990474 UI USA

REMARKS

Response to Office Action dated August 7, 2001

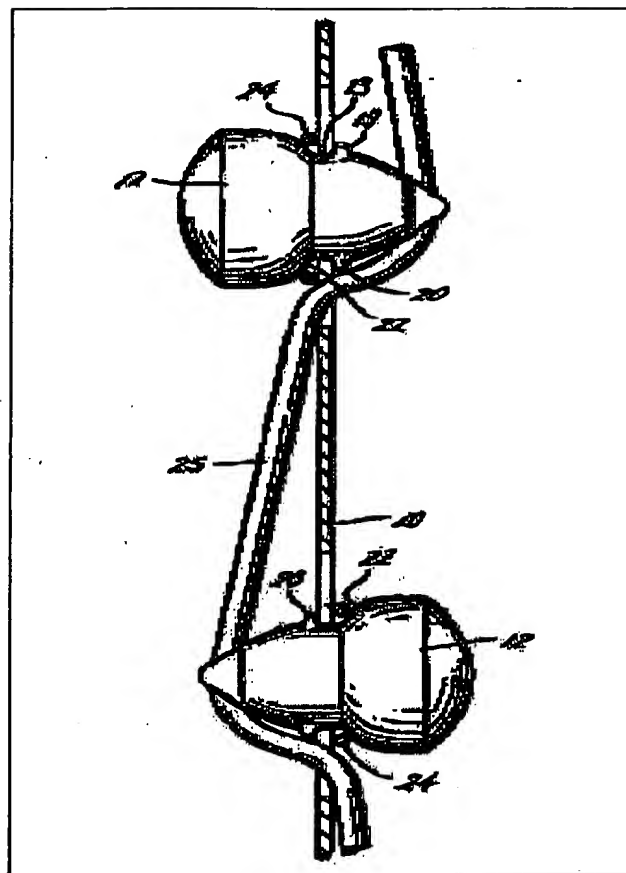
Figure 1 from Blair is reproduced below. Note that Blair requires an elastomeric ring 24 to secure the charge holder. Clearly, Blair did not consider the tab/slot arrangement alone suitable. The lack of a need for this elastomeric ring is one significant improvement of the present invention over Blair. Not only does the need for the ring add steps in assembling and disassembling the apparatus, but it is well known that an elastomeric ring is susceptible to degradation in the extreme downhole environment of a well.
